Name of Proposed Subdivision ROCKWALL VILLAGE ADDITION NUMBER 1

SITE PLAN/PRELIMINARY PLAT/~~FINAL PLAT~~

Name of Proposed Development: Rockwall Village

PROPOSED PLOT PLAN - S.W.C. I-30 AND F.M. 740  
 ROCKWALL, TEXAS

PROJECT: **ROCKWALL VILLAGE**  
 S.H.C. I-30 AND F.M. 740  
 ROCKWALL - TEXAS

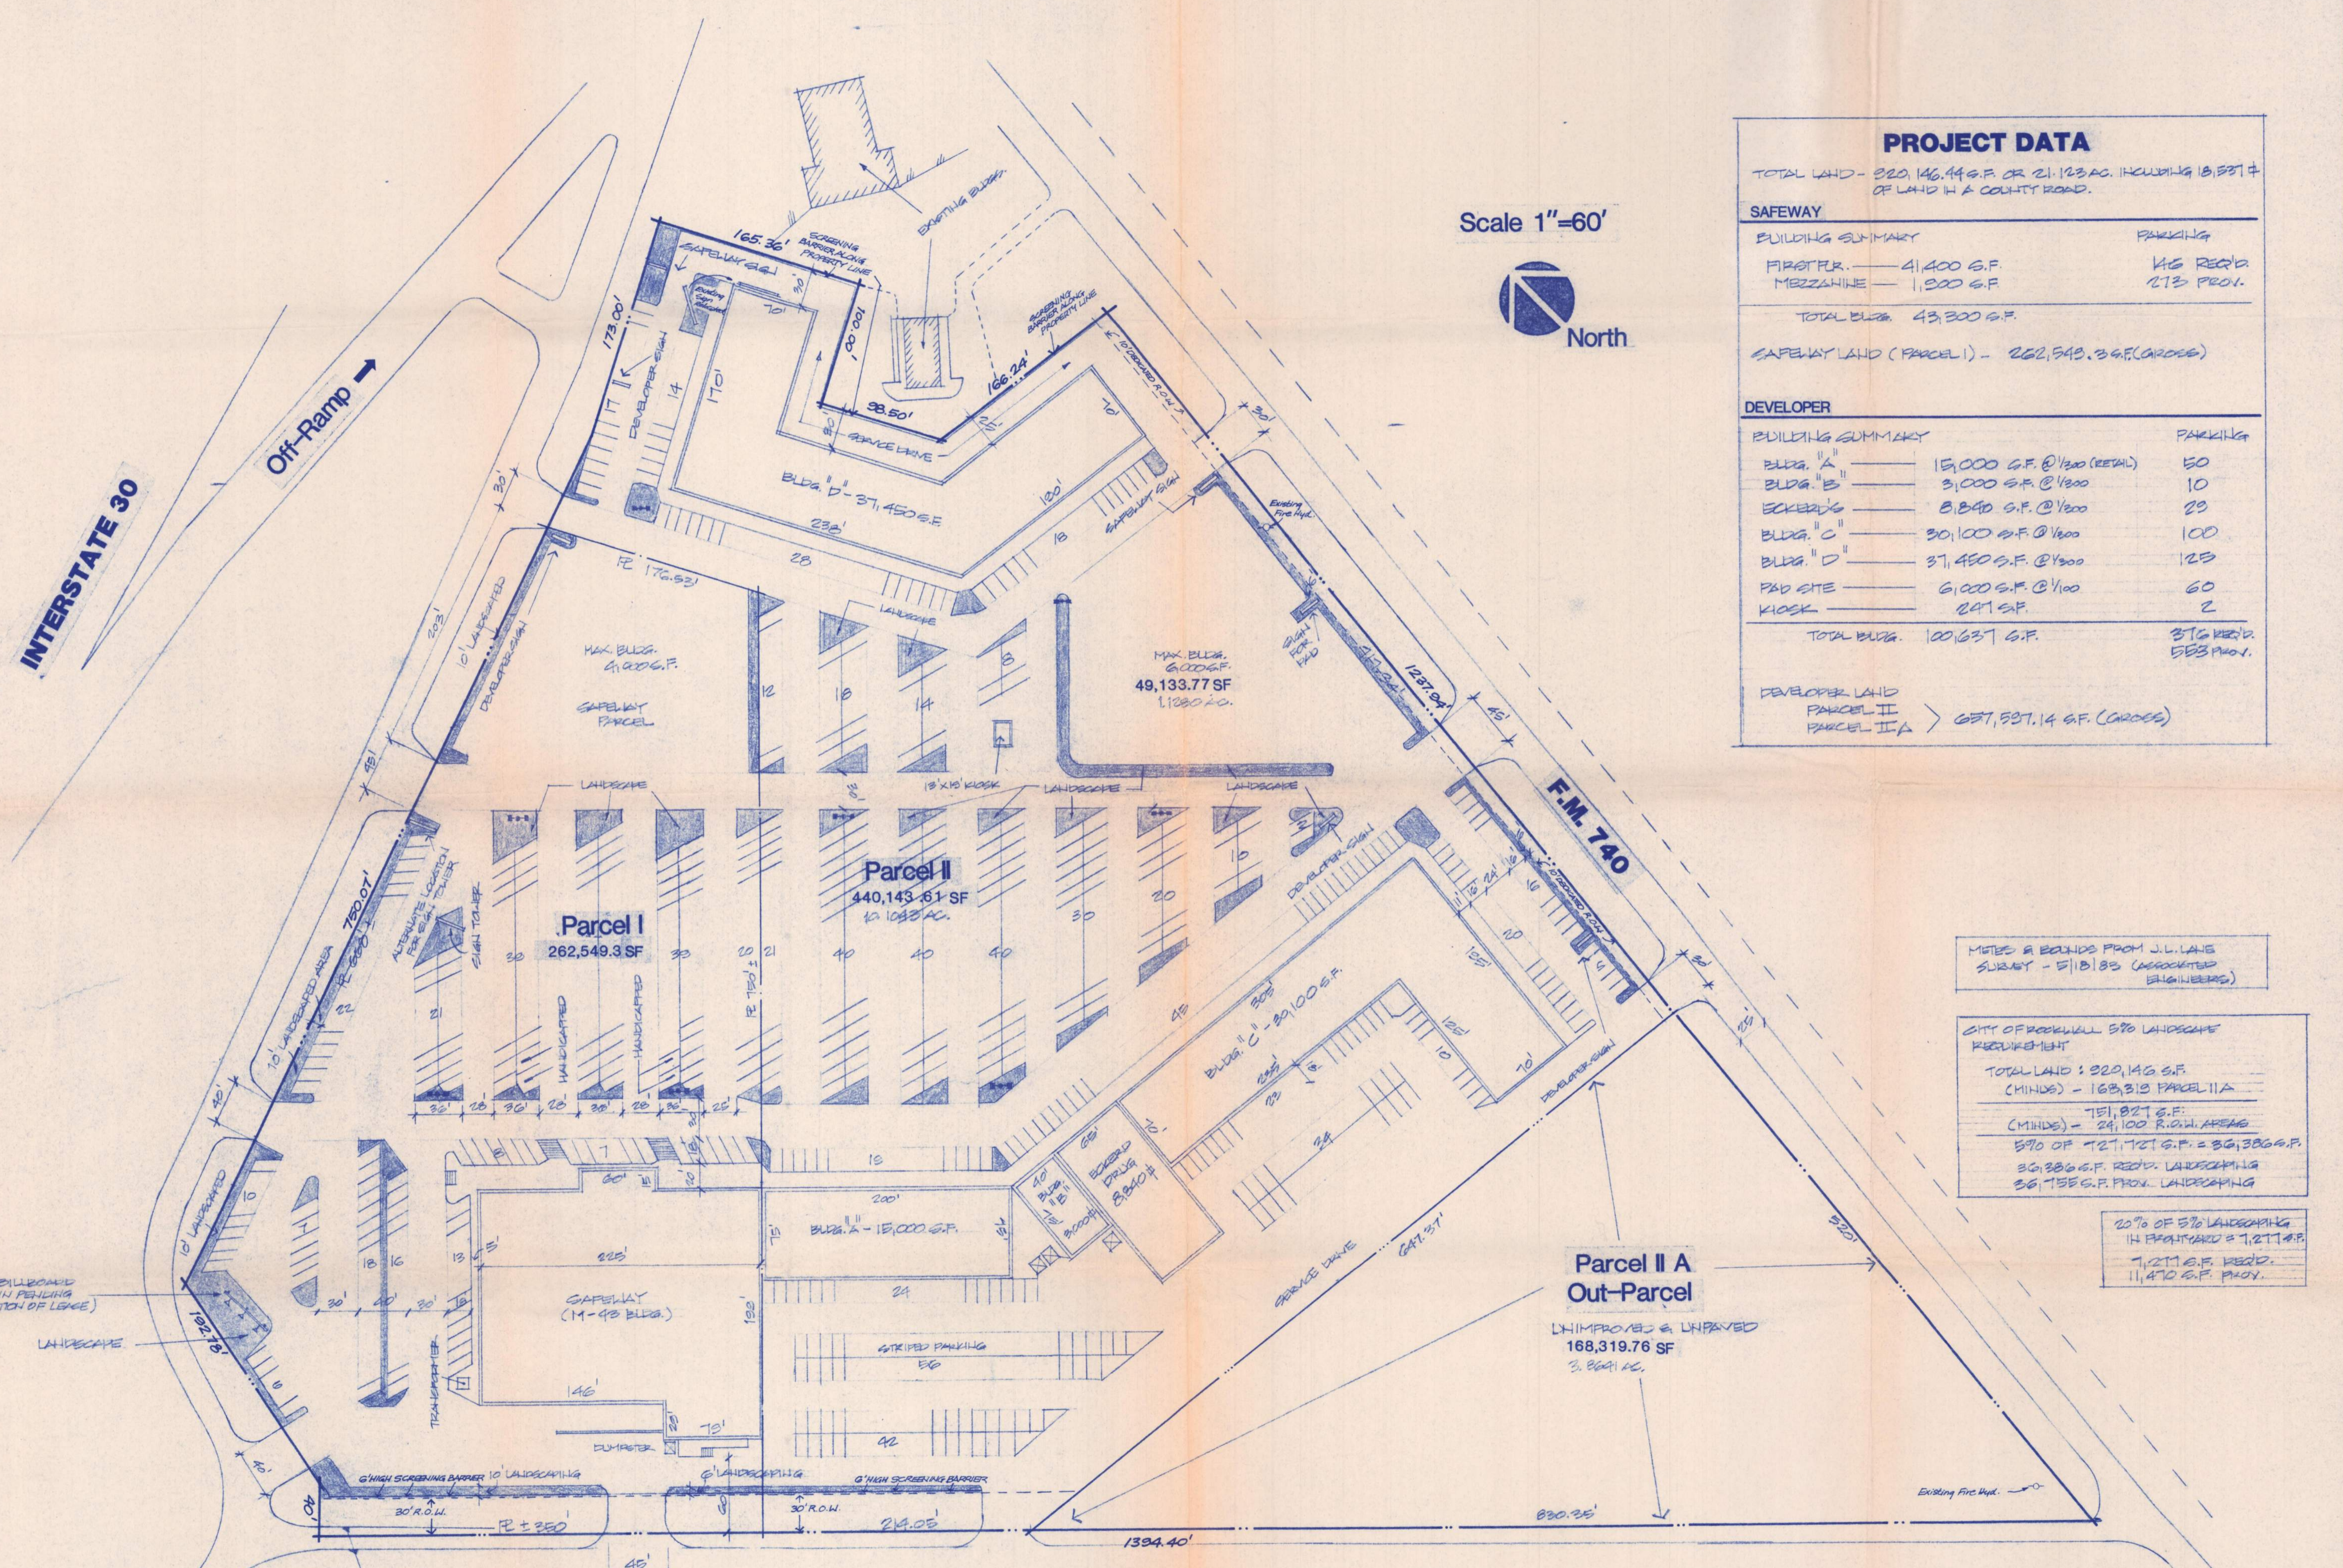
Need to topographic check  
 information to Exit on a  
 site distance this could be dangerous and average speeds.  
 2 entrances/exits and  
 have 3 off this frontage.  
 should probably eliminate  
 Drive is to close  
 to offramps  
 from - should  
 be  
 eliminated.  
 15 there on existing  
 drive here?

Should probably put Parcel #1  
 on a separate sheet of parking  
 and landscaping detail out

State road - will  
 the City be responsible  
 for maintenance

SHOW APPROXIMATE  
 LOCATIONS  
 OF ADJACENT  
 BUILDINGS  
 AND  
 DRIVEWAYS

Dimension existing and future R.O.W.  
 Scale 1"=60'

Show dimensions  
 - height  
 - size

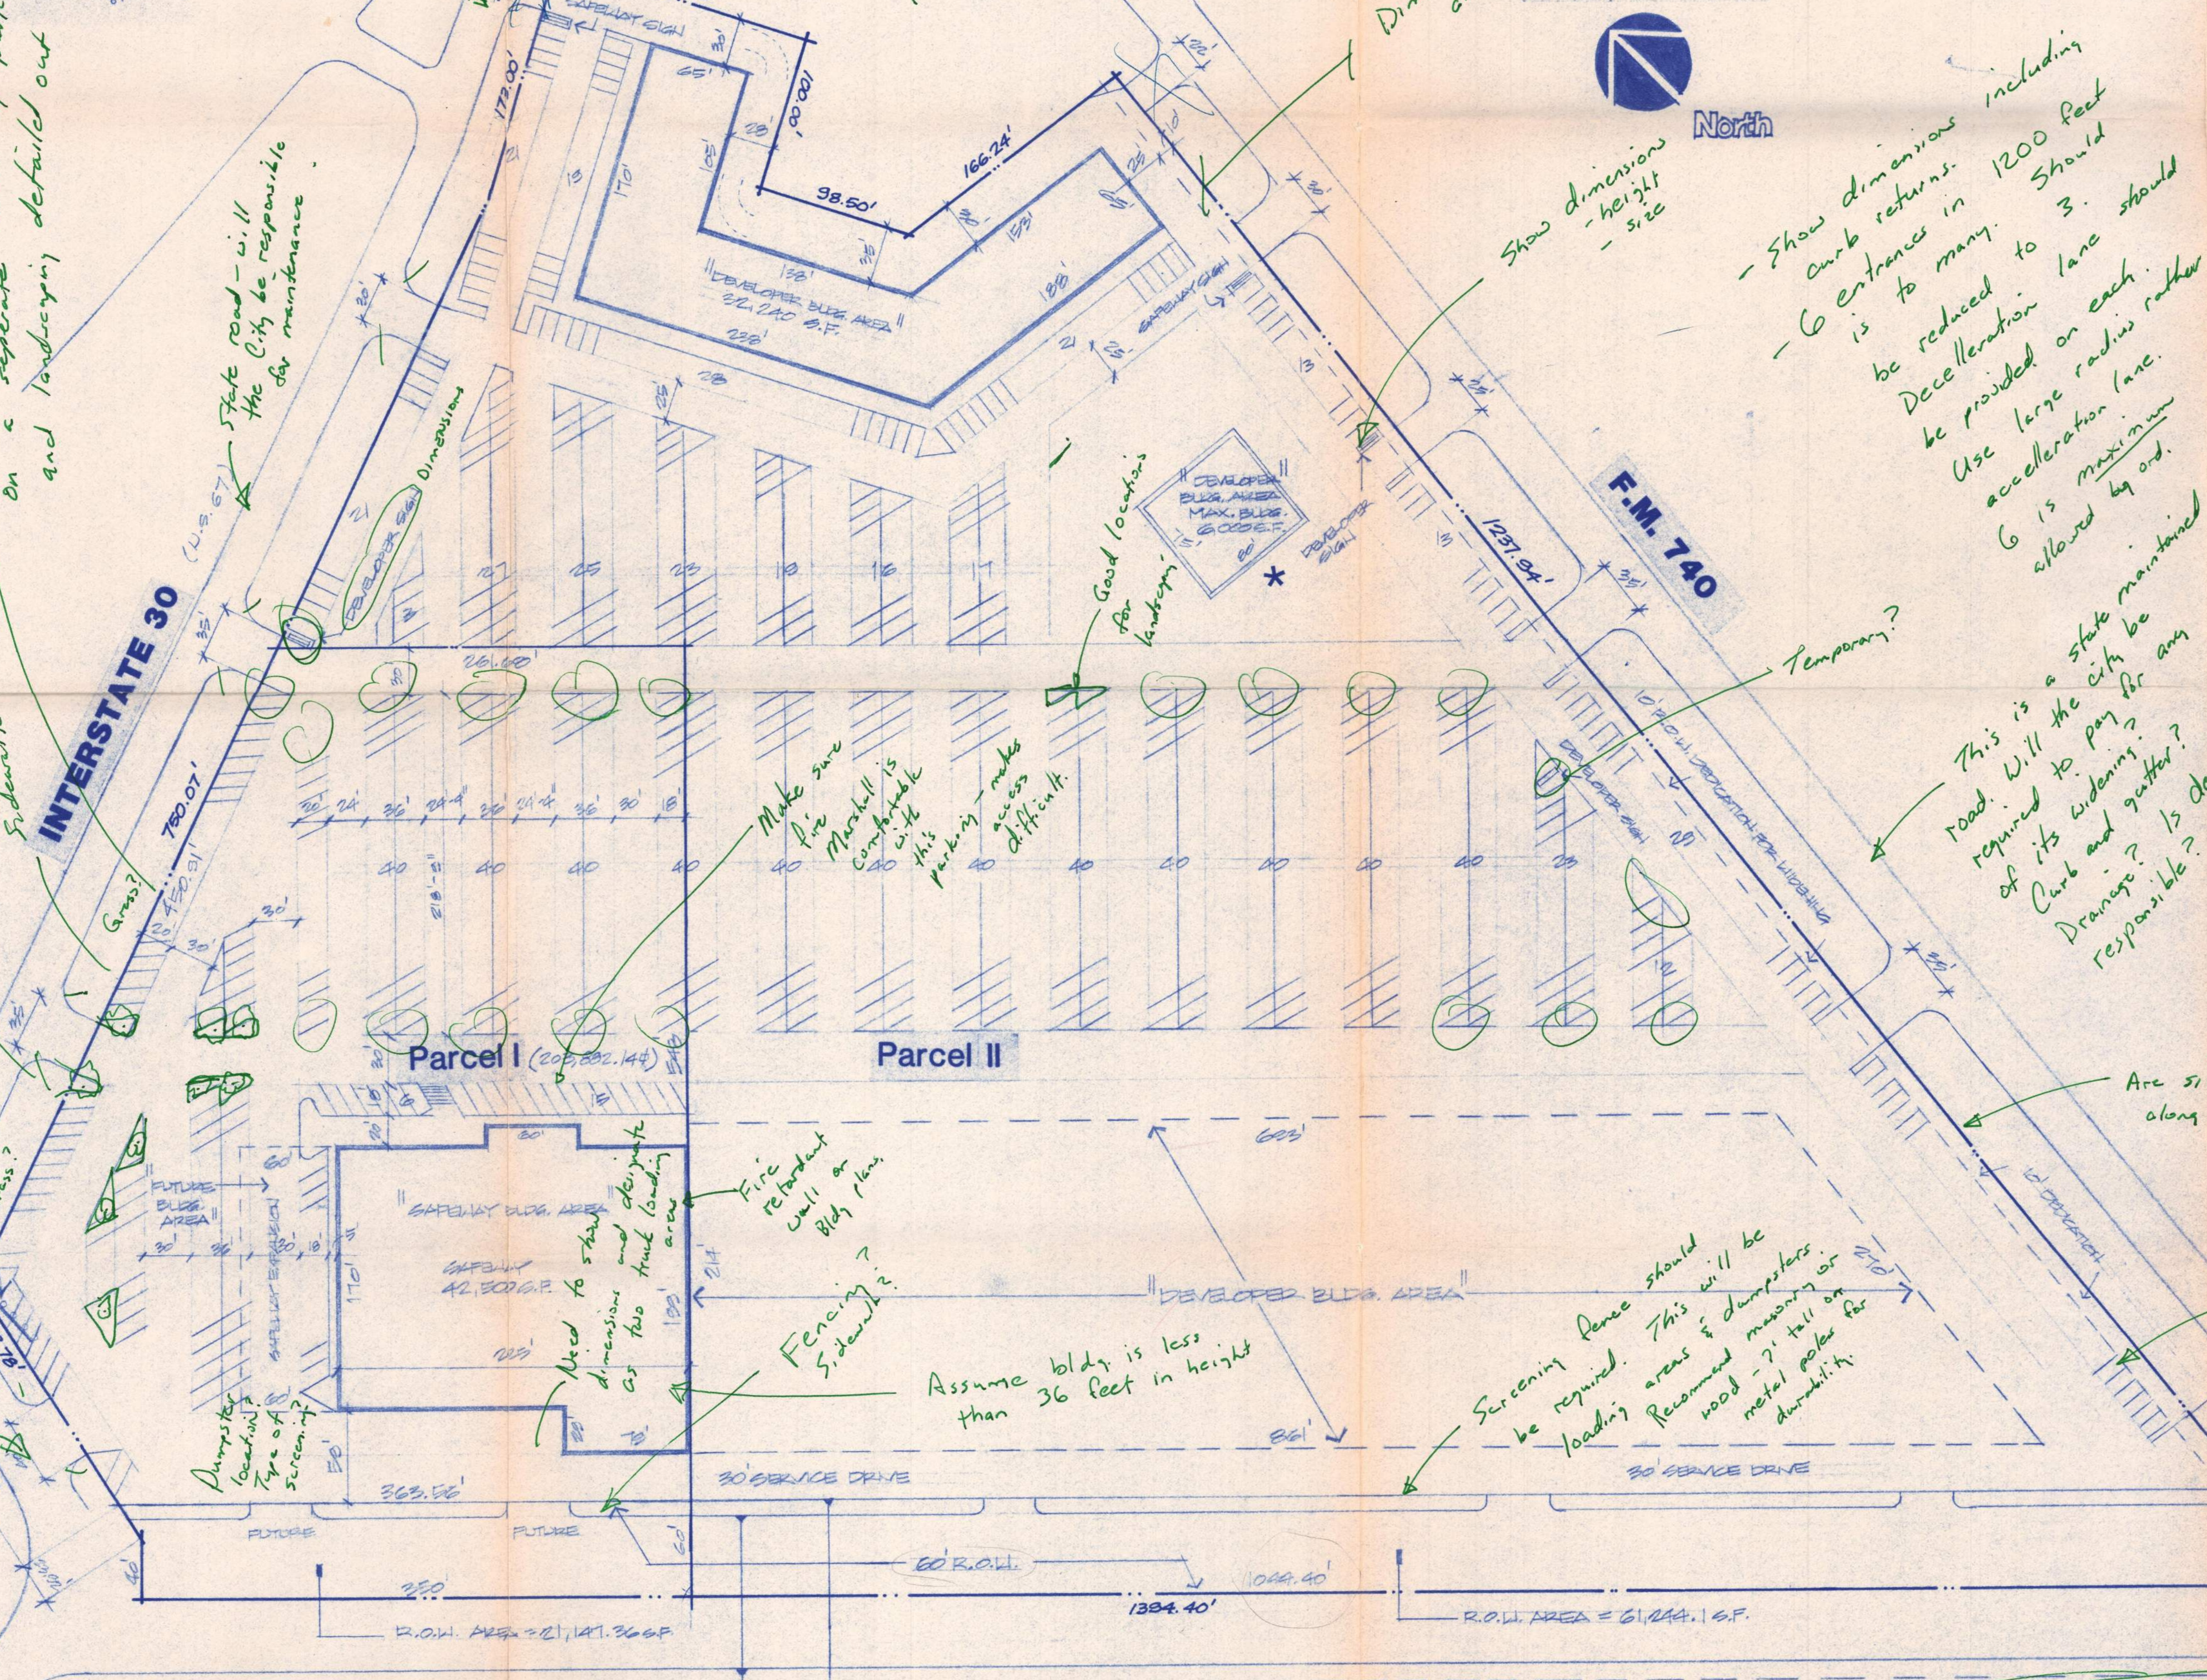
Show dimensions including  
 curb returns.  
 6 entrances is to many.  
 Deceleration lane should  
 be provided to 3.  
 Use large radius rather  
 acceleration lane  
 G is maximum  
 allowed by ord.

This is a state maintained  
 road. Will the city be  
 required to pay for any  
 of its widening?  
 Curb and gutter?  
 Drainage? Is developer  
 responsible?

Are sidewalks required  
 along 740?

Will parking be up  
 against ROW?  
 Will there  
 be any  
 landscaping?

Make sure that you are approving Phase I only.  
 Phase II might be approved conceptually, but is not  
 in final form.

- Need to designate building materials to  
 be 100% fire resistant & 90% masonry.  
 - Need to note amount of landscaping  
 5% of 203,882 sq ft = 10,194 sq ft of  
 on-site landscaping  
 areas w/in Phase I.  
 Do not count R.O.W.  
 - 20% of area between bldg + street to be  
 landscaped.

- Need to calculate building  
 coverage and FAR and  
 indicate.

Appears to  
 be more than  
 adequate for  
 Phase I
